Notice of the dimension of hook cover opening section change for 5t hoist

Subject	Notice of the dimension of hook cover opening section change for 5t hoist	Date of issue	July 31th ,2015	Notified to
		MITSUBISHI ELECTRIC FA INDUSTRIAL PRODUCTS CORPORATION 1-1-1 Imajuku-Higashi, Nishi-ku, Fukuoka 819-0192 TEL 092-805-3400		Sales agent

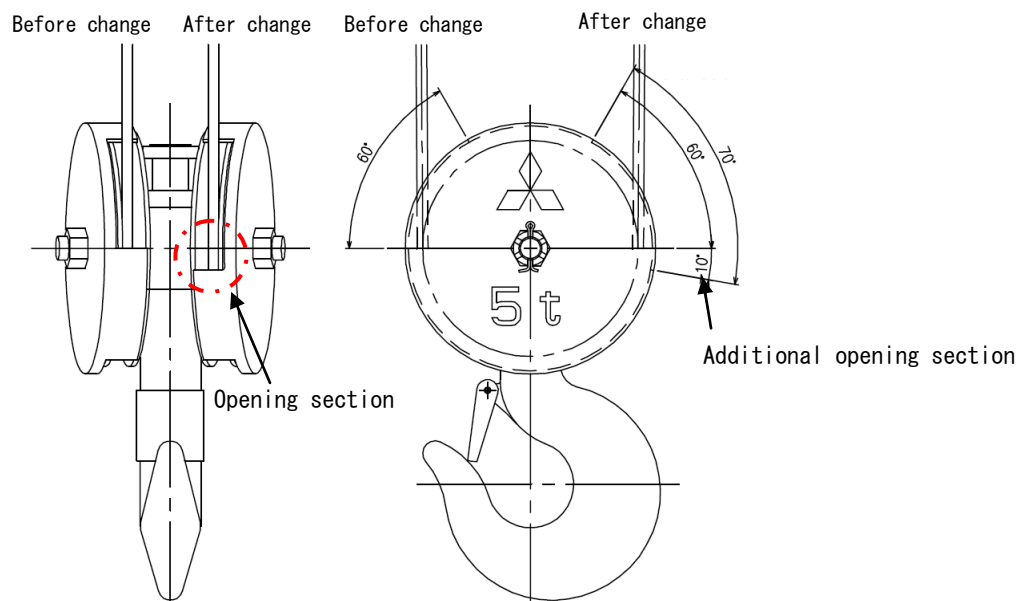
The dimension of hook cover for 5t hoist is changed as below.

To prevent the wire rope from contacting with hook cover.

There is no functional problem even if only the one side of hook cover of old model (the model before change) is changed to new hook cover, although the dimensions of hook cover opening sections are different.

Compatible. 「The Part code (03H458) 」 is not changed.
